## Staff Report to Advisory Design Panel Planning and Development

FILE: 3060-20-2024-03

**REPORT DATE:** September 19, 2024      **MEETING DATE:** October 09, 2024  
**TO:** Advisory Design Panel  
**FROM:** Jaimie Jagpal, Development Services Technician  
**SUBJECT:** Development Permit Application for 19516 Hammond Rd.

Figure 5: Site Plan

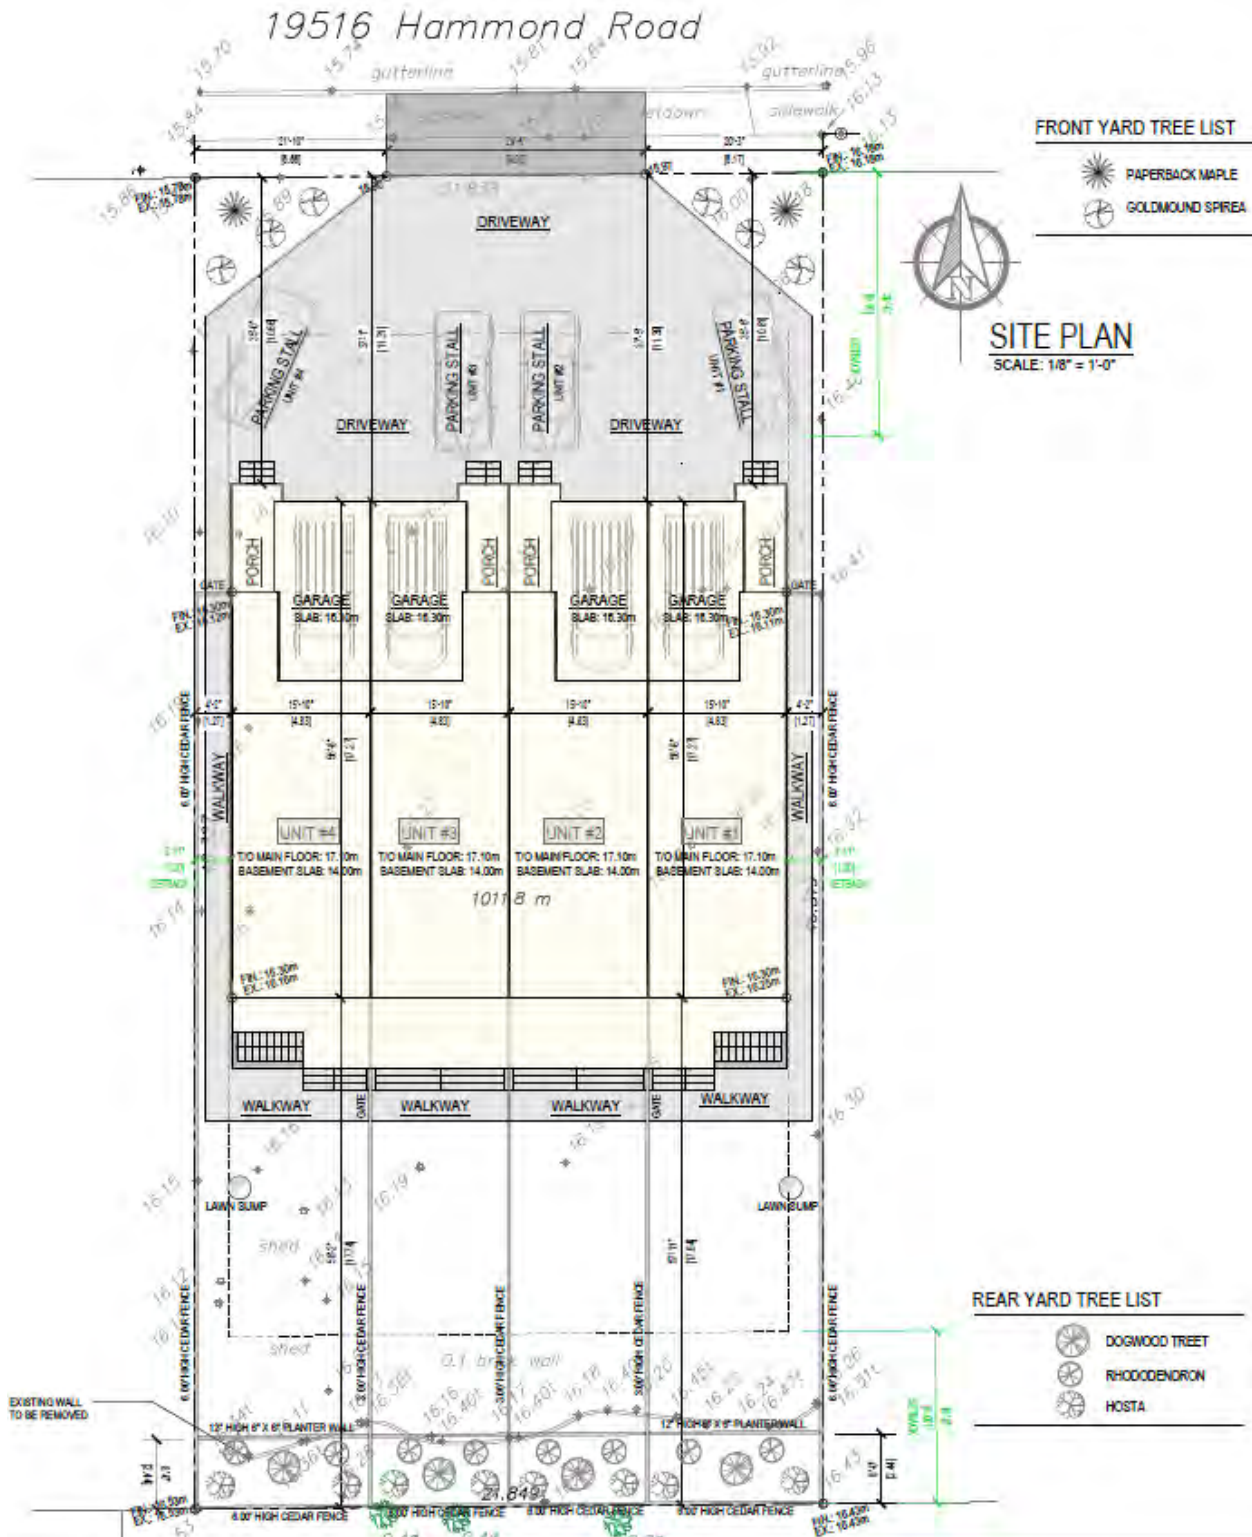
The townhouse design raises questions regarding its adherence to key Development Permit Area (DPA) landscaping and storage guidelines. The City would appreciate feedback on this application from the Advisory Design Panel, where it can be evaluated for design quality, community impact,

and adherence to the newly established zoning standards. In particular, ADP is asked to comment on the design's adherence to the following design guidelines which were raised as points of concern during the internal review process:

- 9.7.2 a. ii. Emphasis of front entryways and pedestrian access, in order to create a pedestrian oriented streetscape through front yard landscaping and tree planting
- 9.7.2 a. iv.) Integration of landscaping within driveway areas to soften impacts of front yard parking and hardscape environment
- 9.7.4 b) Natural hedge landscaping between homes, which could replace standard fencing
- 9.7.4 c) Create a greener, more inviting interface between buildings and streets
- 9.7.5 a) Provide dedicated, secure spaces for adult-sized bicycles
- 9.6.6 a) Provide space for garbage, recycling, and compost bins with convenient access for residents
- 9.6.6 b) Location and design of the space should allow for ease of access so that residents are able to move the bins out on collection days.
